Subject: Duke Energy Carolinas, LLC (Duke)
Catawba Nuclear Station, Units 1 and 2
Docket Numbers 50-413 and 50-414
Technical Specifications (TS) and/or Bases Sections:
3.3.2, Engineered Safety Feature Actuation System
(ESFAS) Instrumentation
3.3.3, Post Accident Monitoring (PAM) Instrumentation
3.5.4, Refueling Water Storage Tank (RWST)
3.6.6, Containment Spray System
License Amendment Request for Emergency Core Cooling
System (ECCS) Water Management Initiative

Response to NRC Request for Additional Information

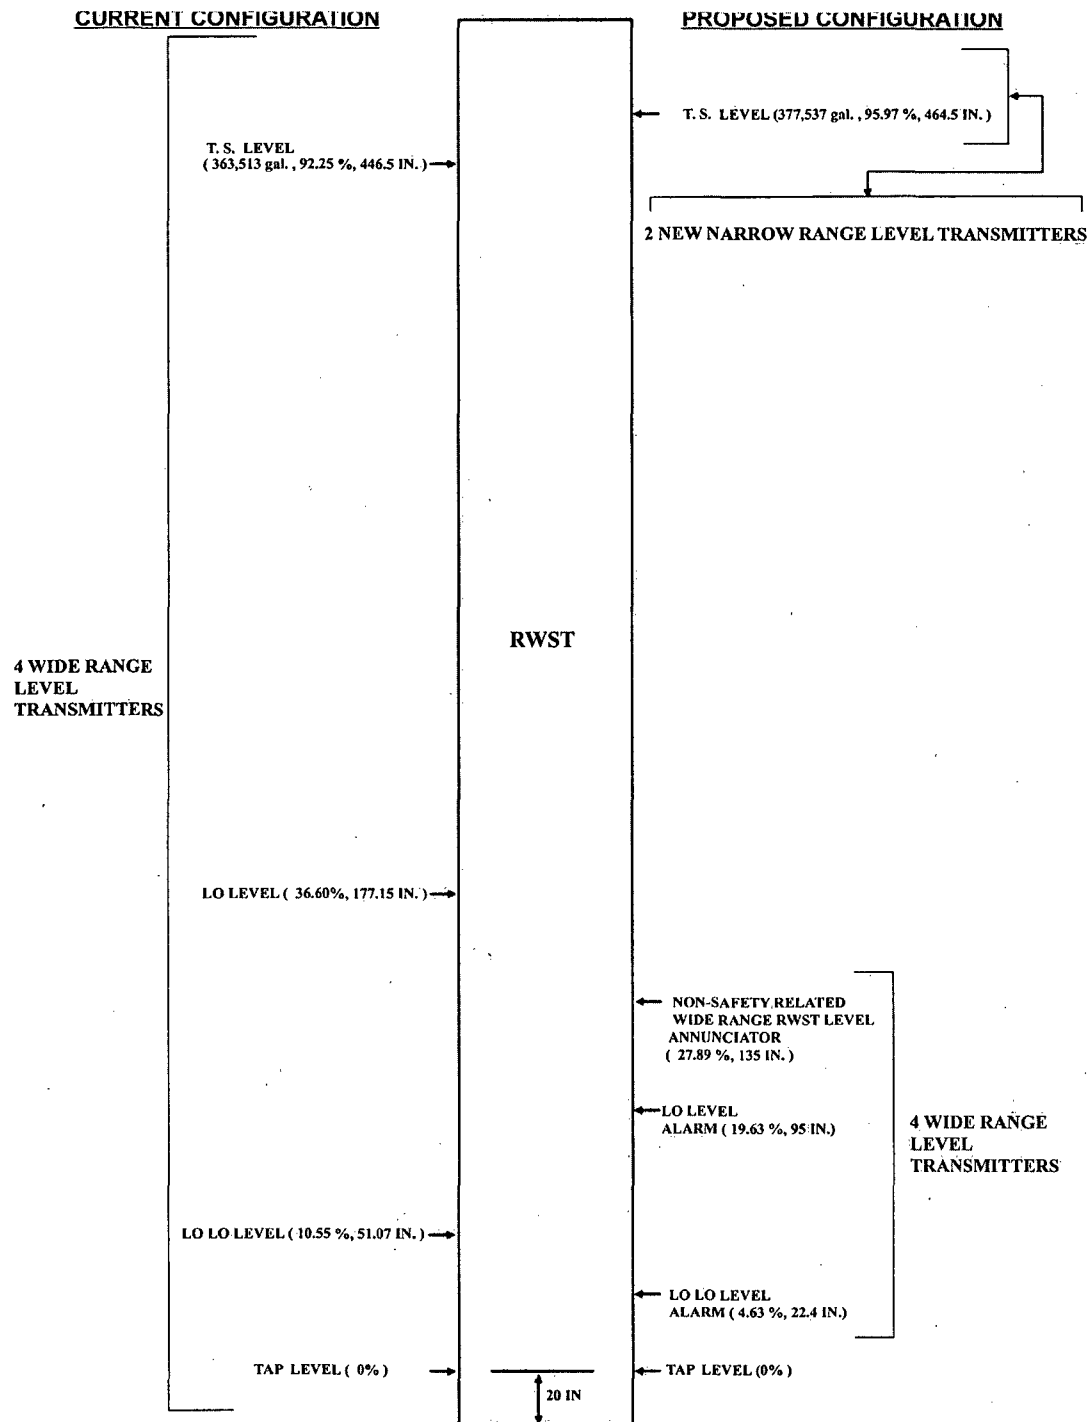
3. In addition to these two questions, Duke indicated that a figure provided in the June 18, 2009 RAI response would be revised to show values in both inches and percent. The revised figure follows.

NOTE: ADDITIONAL ALARMS ARE PROVIDED TO ENSURE THE T.S. LEVEL IS MAINTAINED
